Permit Type	Permit Number	Opened Date
Building/Residential/Misc/Tanks	202400021	08/28/2024
Description of Work		
SFD/ Install Dixie Land Leased underground 500 gallon propane tank and service line to house

APPLICATION FOR VARIANCE

5236 GREEN BRIDGE ROAD, DAYTON, MD 21036

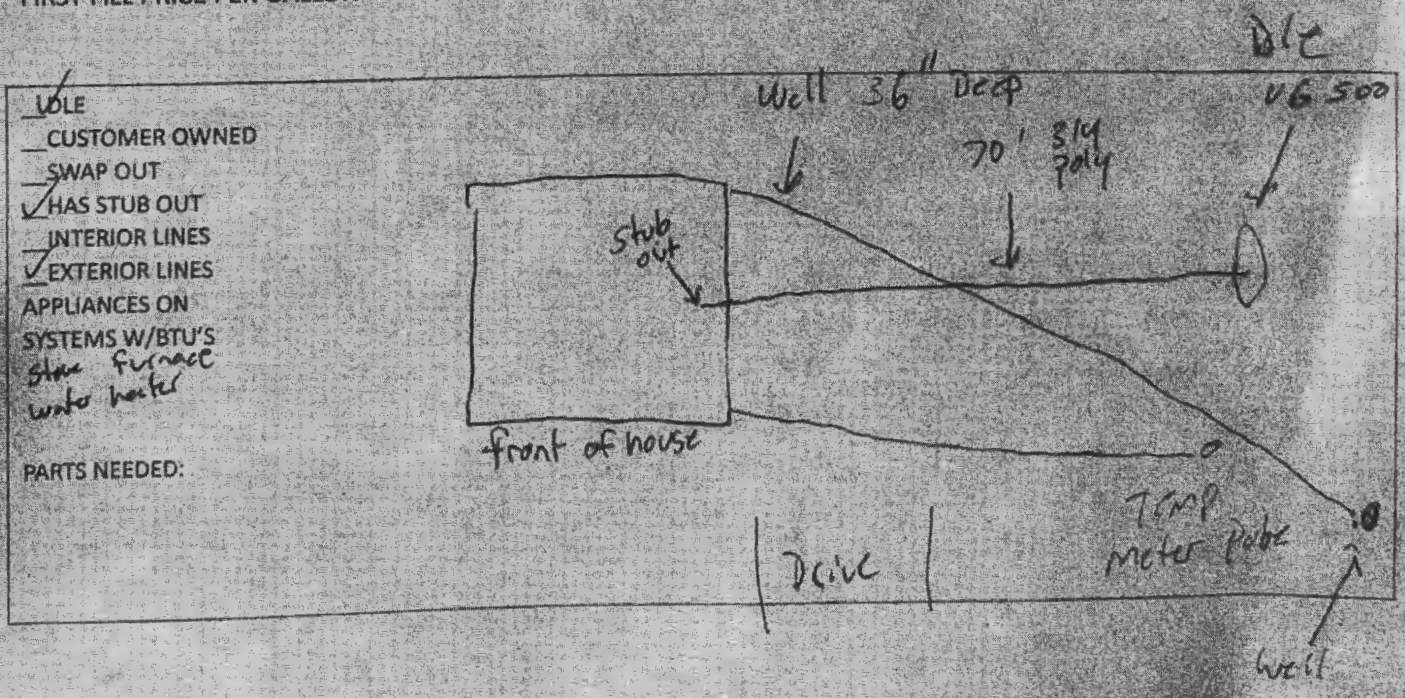
9/10/24 - BP on hold, hand drawn plan can't be used for review requested a revised scaled plan ~~plan~~ w/ w/s ~~setbacks~~ setbacks (P)
 9/10/24 - site inspection revealed that the propane tank was installed ~~not~~ before ~~the~~ the permit was issued, and it was installed on 37' away from the well. (P)

I said the ~~Scale~~ Scale was off
on the latest version of
the site plan. He has the
distance of the lp tank to the
house as 70' but on the scaled
plan it should be 60' -
Said that I'd do a site
visit and if it measures
at 70' away from the
house then it's off the property.
(10)

Good Morning Matt, as I explained last week, the setback for the underground propane tank is at least 50' you're currently at 37'. Additionally, with the poorly hand drawn site plan you submitted which doesn't show property lines, it's impossible to tell if the lp tank has been installed on or off the property.
